Town of Kittery Planning Board Meeting November 18, 2021

ITEM 9— 89 Route 236—Final Site Plan Review

Kittery Planning Board
Findings of Fact
For 89 Route 236
Final Site Plan Review

Plan Name:	SITE PLAN
Project:	PARKING LOT EXPANSION 89 ROUTE 236, KITTERY, MAINE
Owner of Record:	JD INVESTMENTEN, LLC NAME 19 BUFFUM RD, UNIT 6, NORTH BERWICK, MAINE

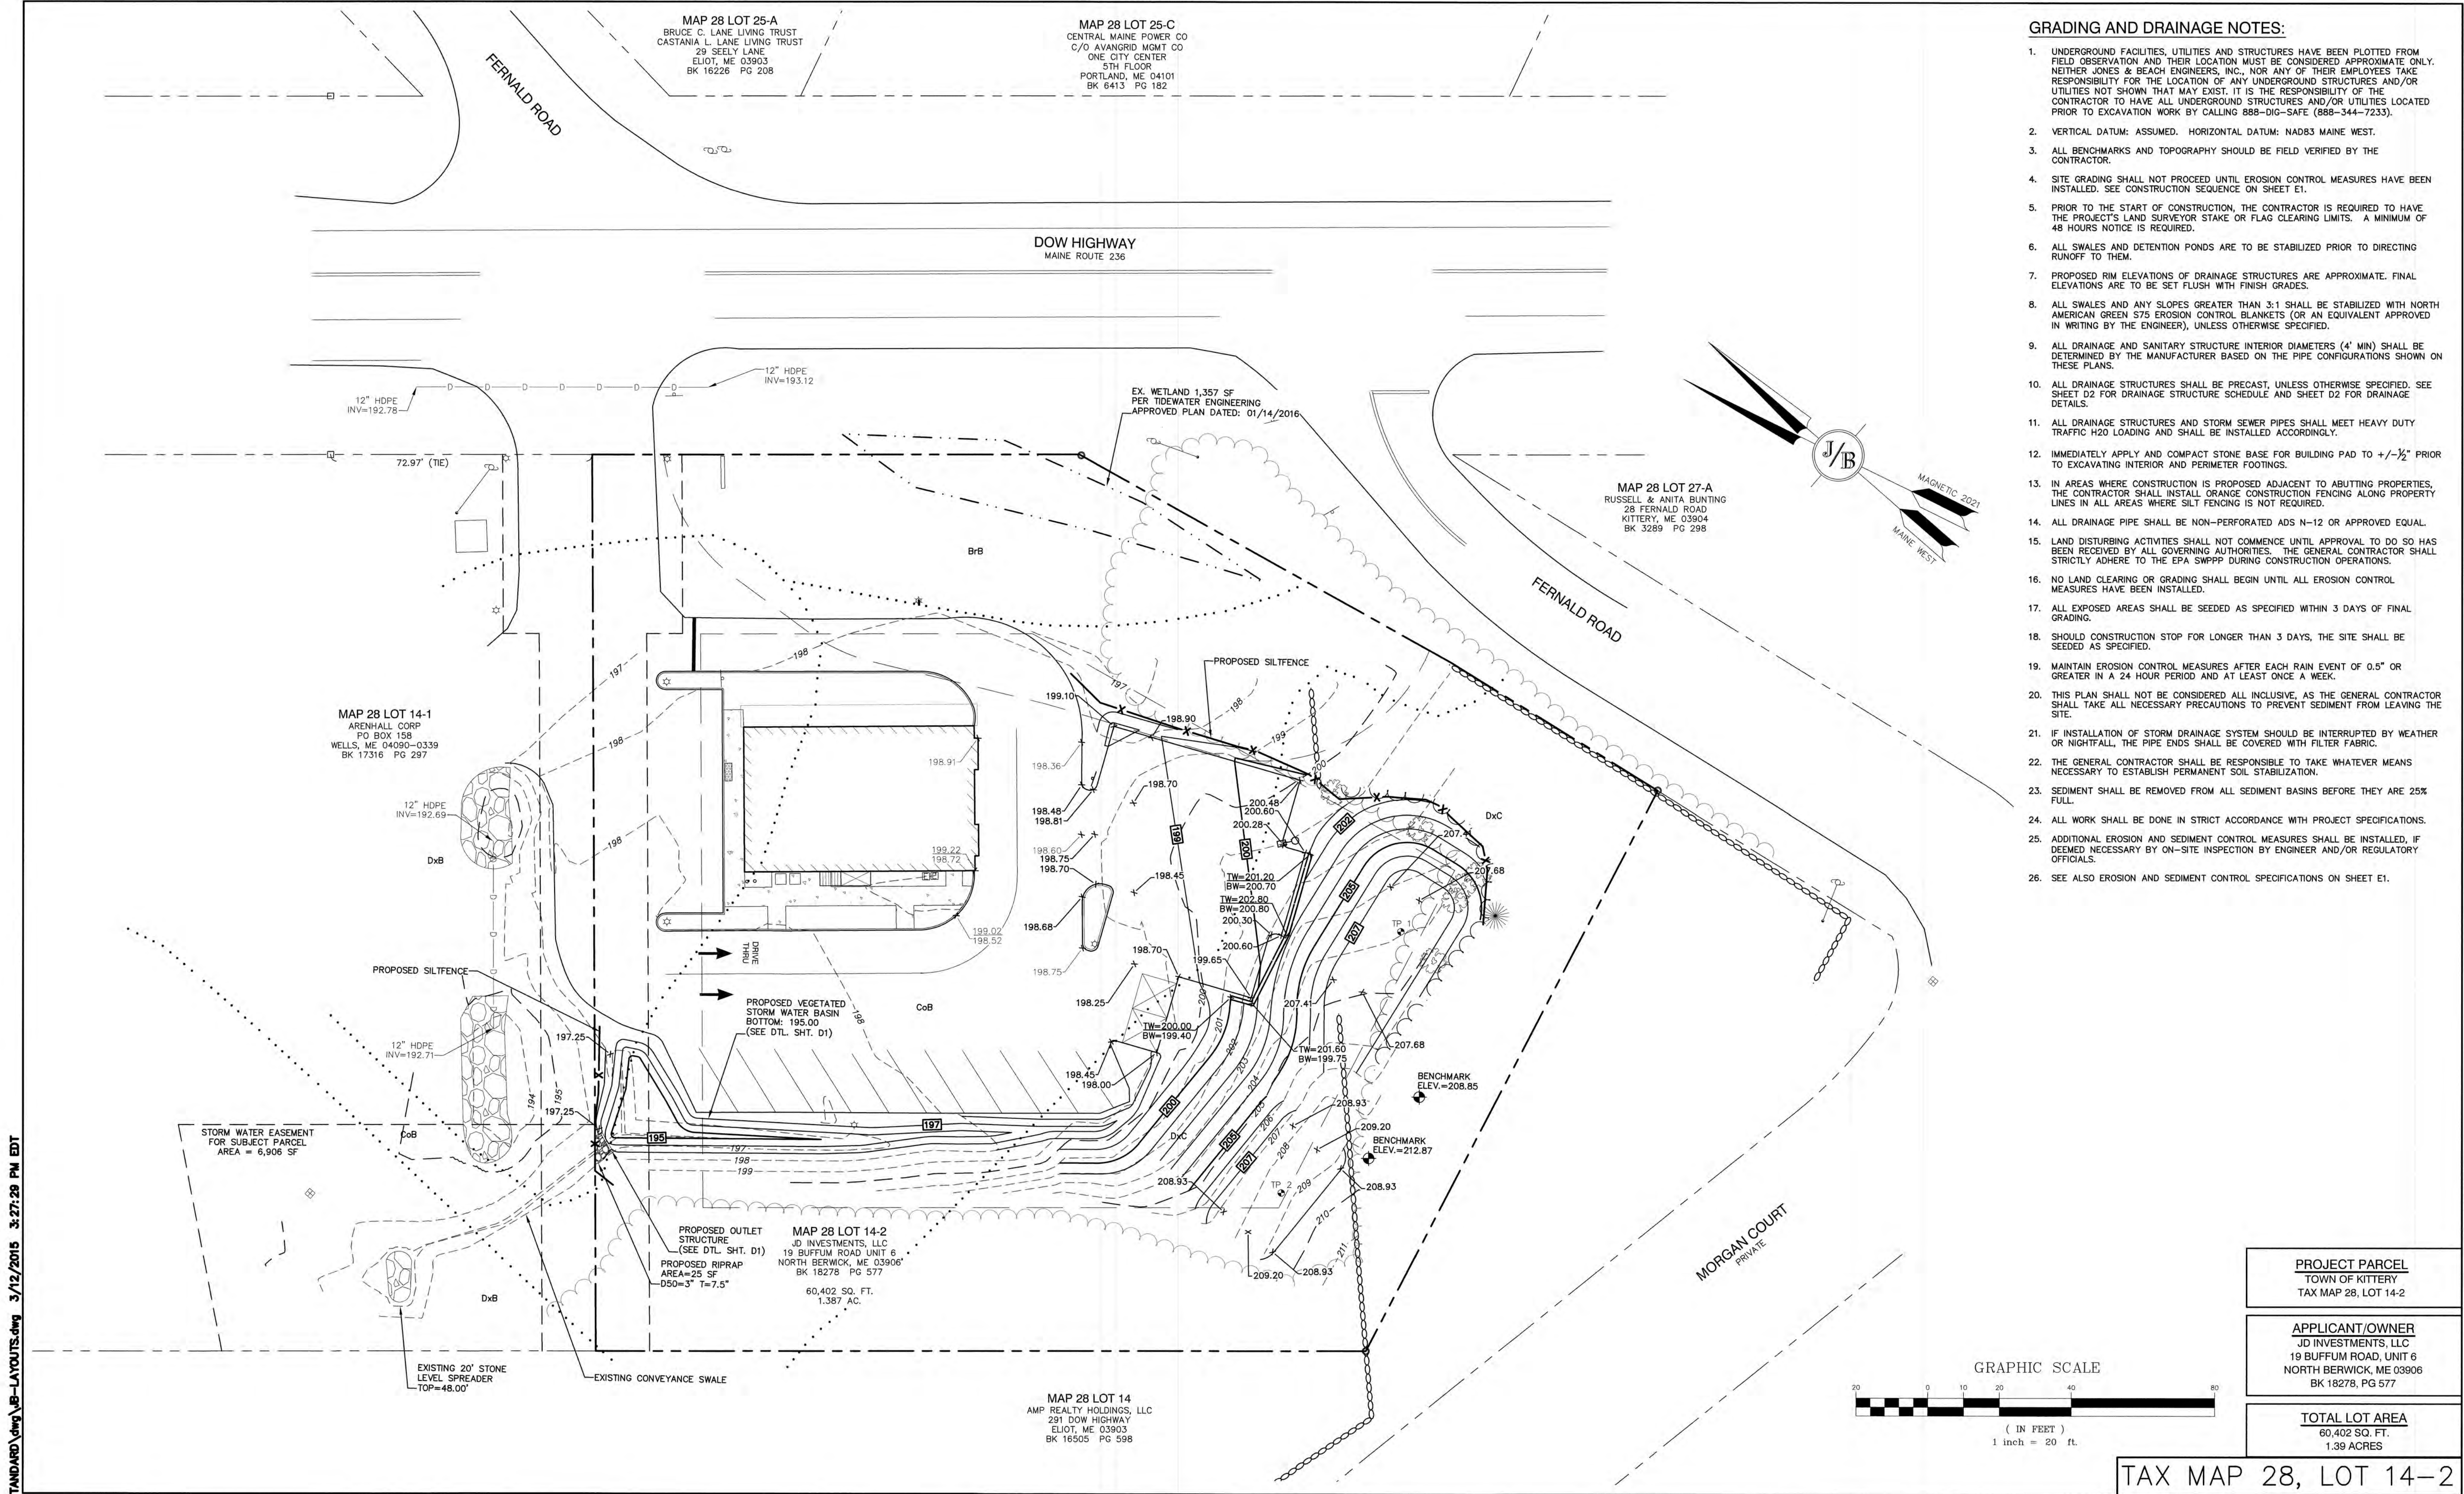
§16.3.2.11.D(5)(d)	Vehicular and pedestrian circulation must meet the general provisions of the Design Handbook	The Planning Board may want to consider having the applicant incorporate pedestrian access (crosswalks) ways from the parking lot to the building in order to create a safe area for people to use to travel to and from the parking lot.

RESPONSE: Note 21 on Sheet C2 has been added stating this requirement.

- The power for the proposed light pole will be pulled from the existing light pole adjacent to the dumpster pad. The conduit is depicted on the Site Plan (Sheet C2).
- The test pits, which were dug in preparation for the replacement septic system, have been added to the plans (Sheets C1 & C4).
- A proposed cross walk has been added to provide safe pedestrian access to the proposed parking field. This cross walk is depicted on the plans.

Plan Name:	GRADING AND DRAINAGE PLAN
Project:	PARKING LOT EXPANSION 89 ROUTE 236, KITTERY, MAINE
Owner of Record:	JD INVESTMENTST, LLC NAME 19 BUFFUM RD, UNIT 6, NORTH BERWICK, MAINE

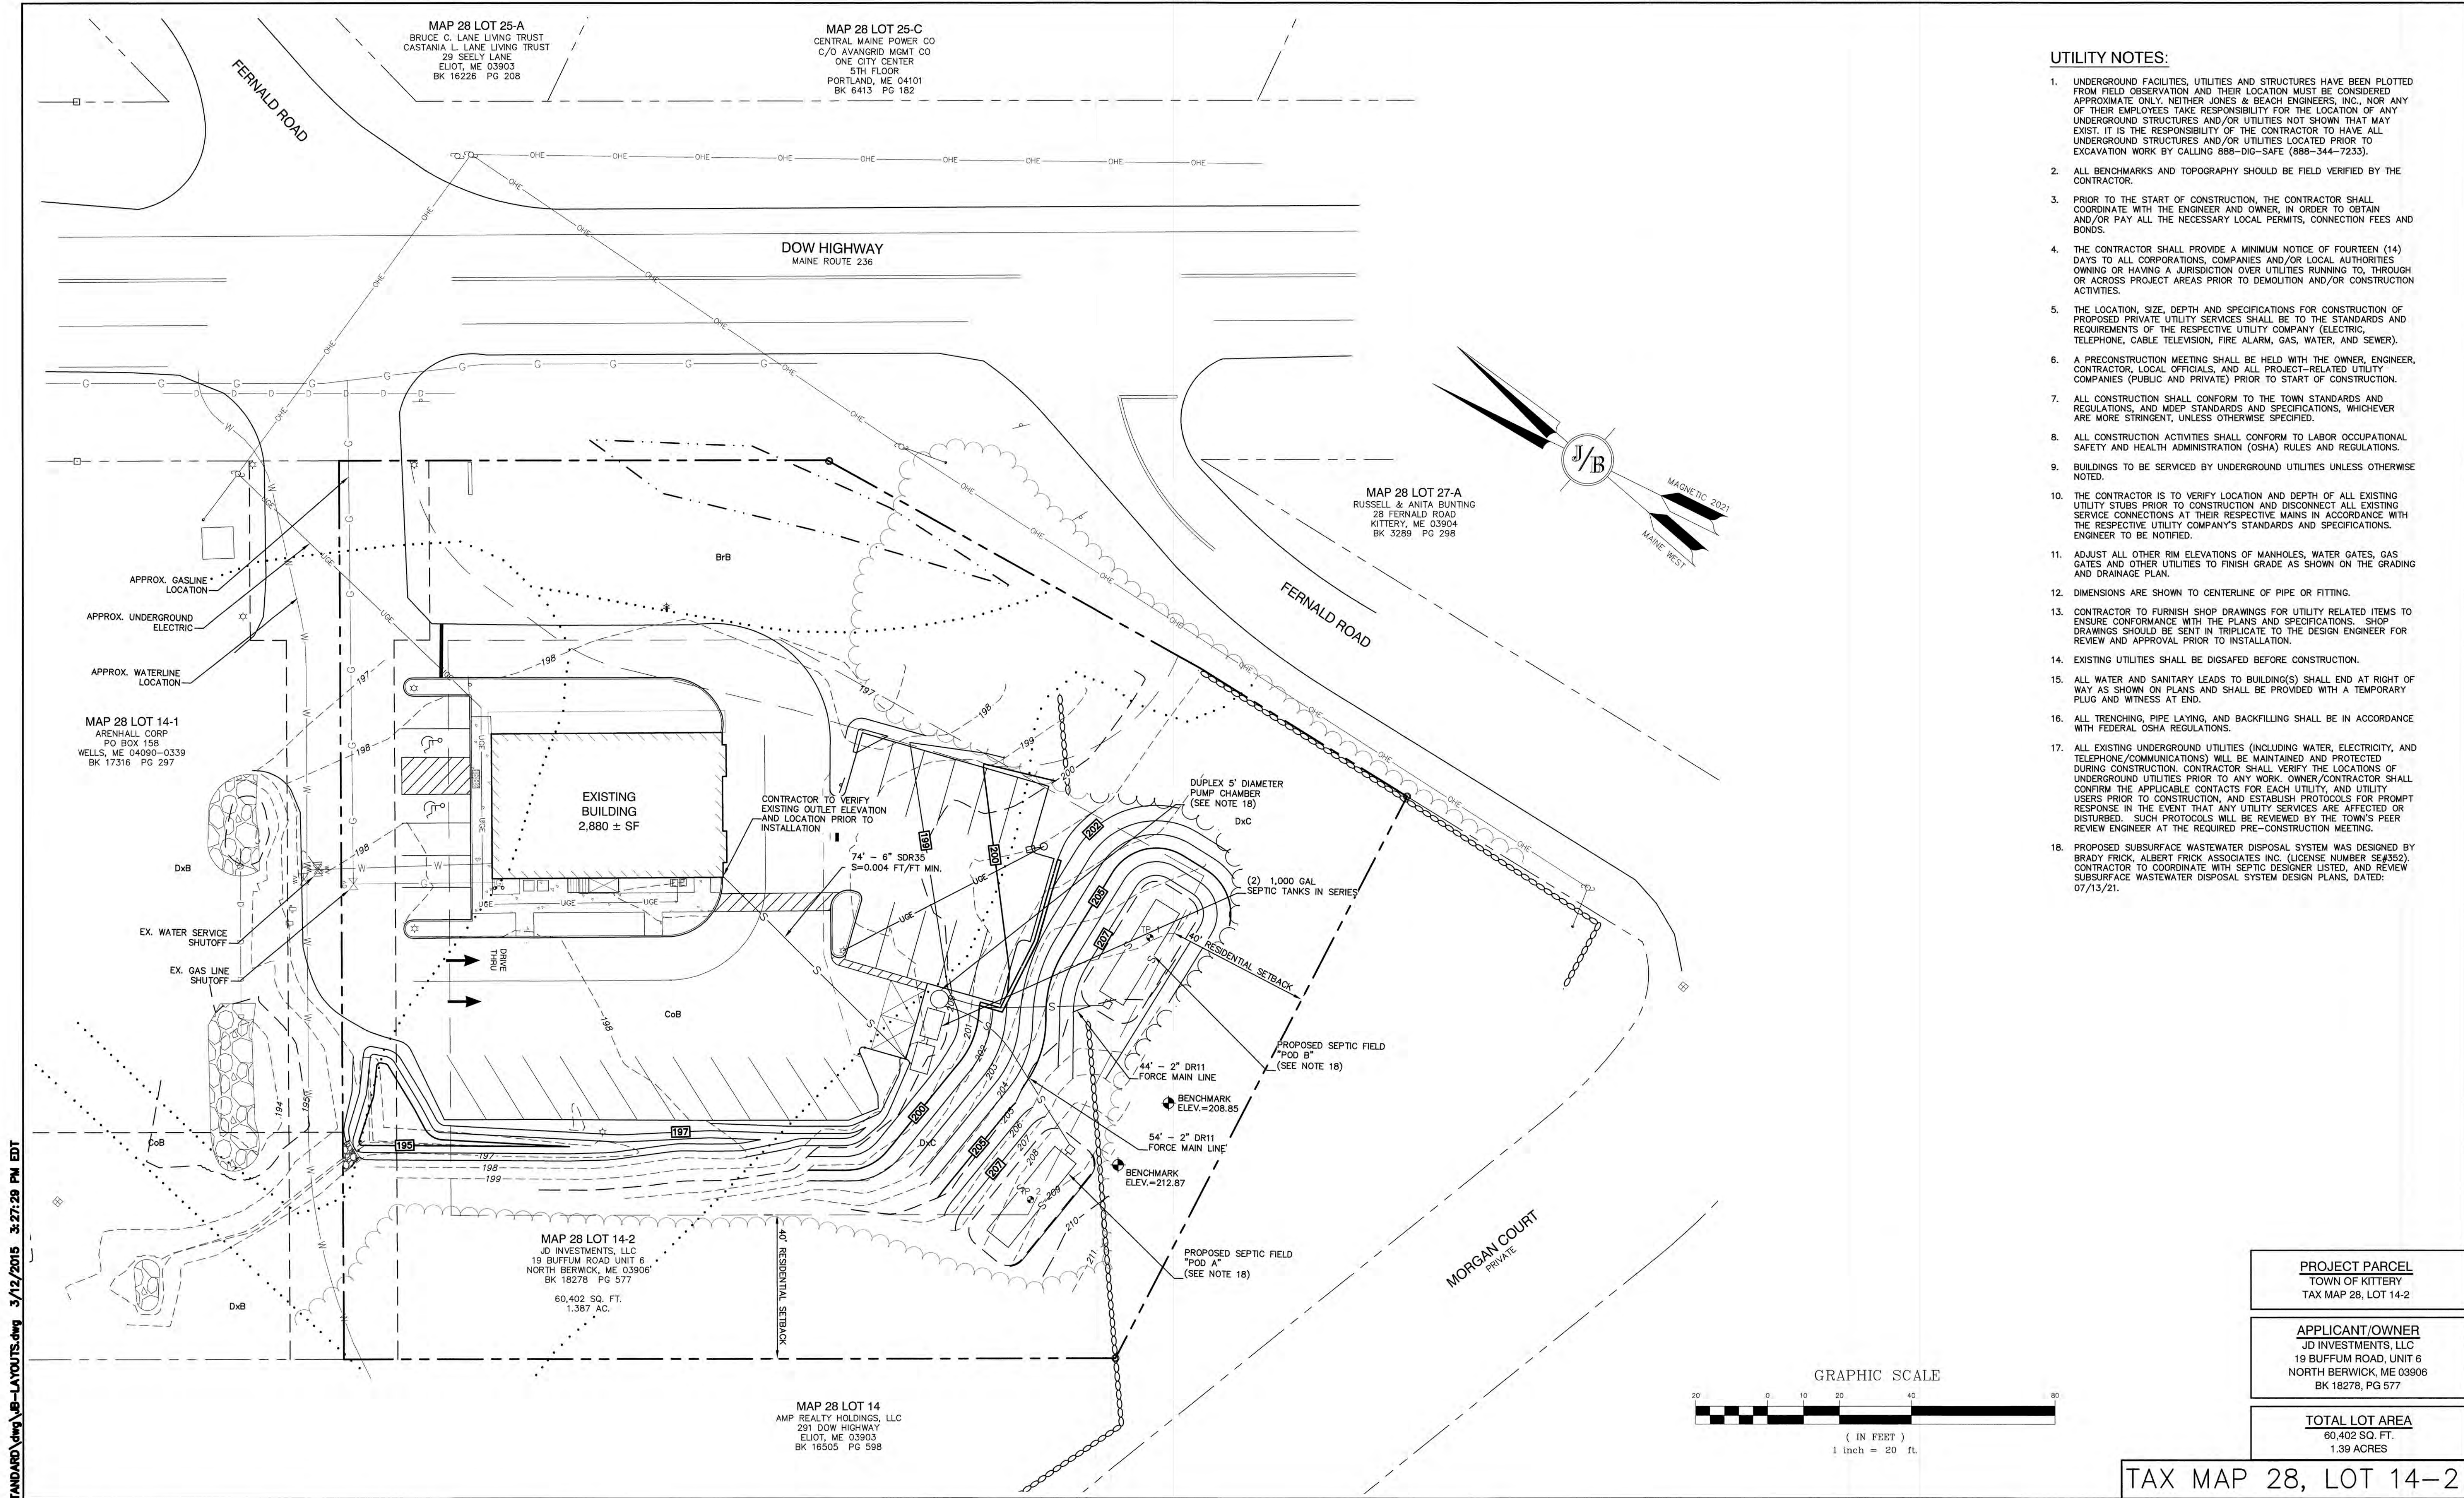
The applicant should provide details for the stormwater basin and outlet structure. Leaders on Sheet C3 reference detail sheet D1, but this was not included in the plan set.

VEGETATED STORM WATER BASIN

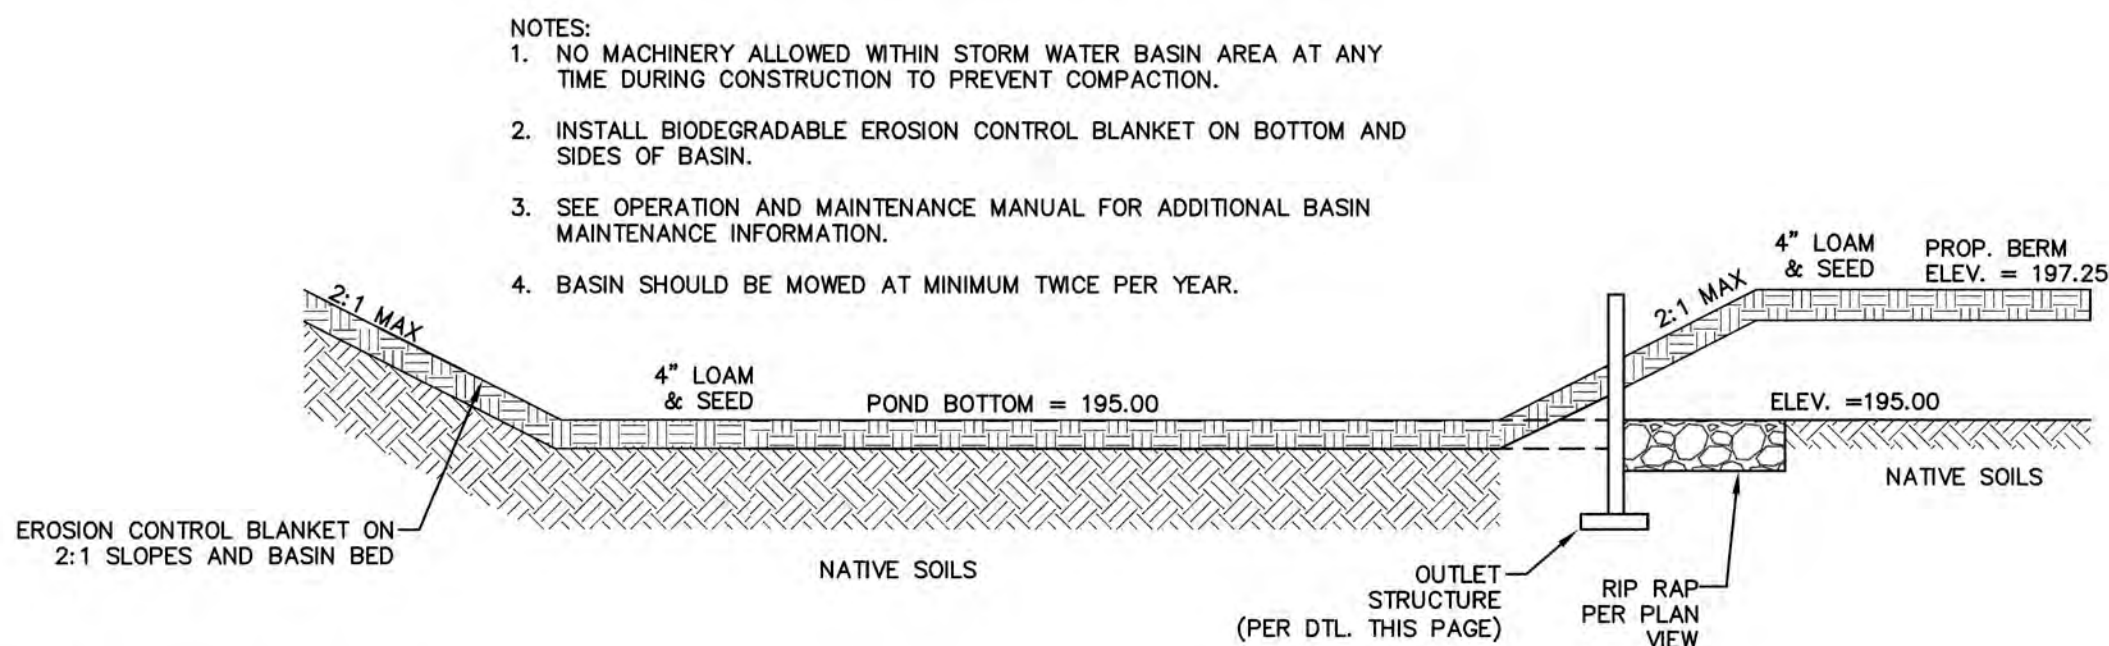
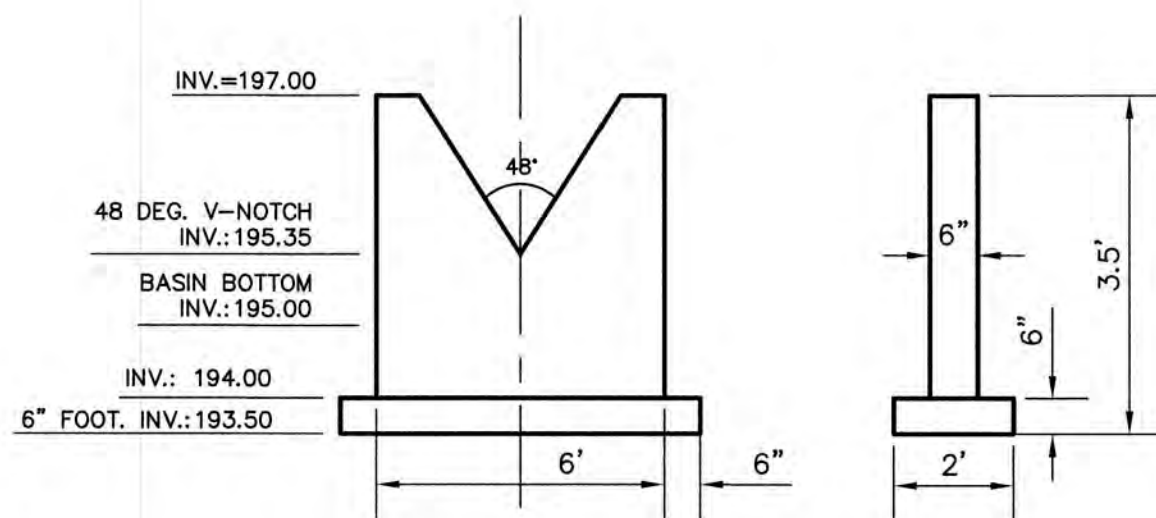
2. *The applicant should provide details for the stormwater basin and outlet structure. Leaders on Sheet C3 reference detail Sheet D1, but this was not included in the plan set.*

RESPONSE: The details in question are included on Sheet D1. This Sheet has been included in the updated plan set included with this letter.
3. *Following the site walk the Town of Kittery requested additional information with respect to the classification of existing pond on site. Gove Environmental Services, Inc. provided a response letter and characterization of the stormwater feature as a detention pond and not a wetland. Their assessment includes discussion of a DEP Stormwater/Site Law permit for maintenance requirements. Does the applicant have this permit? A copy should be submitted to the Town for the project record.*
